From: Smith, Greg Sent: Saturday, January 12, 2019 6:30 PM To: 'contactOPSB@puc.state.oh.us' Subject: Viewshed Analysis 18-0488-EL-BGN

Please post this email as a Public Comment for the Seneca Wind case 18-0488-EL-BGN.

## Figure 9: Cumulative Viewshed Analysis

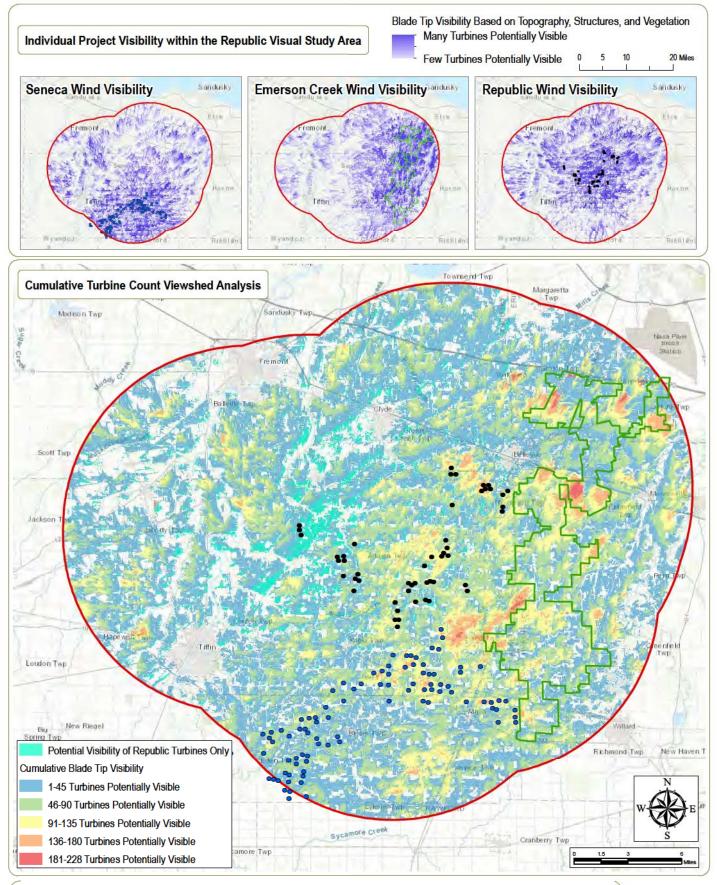
If the cumulative visual impact study is a requirement per the Ohio Administrative Code Chapter 4906-04-08(D)(4) for the Ohio Power Siting Board, where is this analysis for the Seneca Wind project? I have yet to see this study.
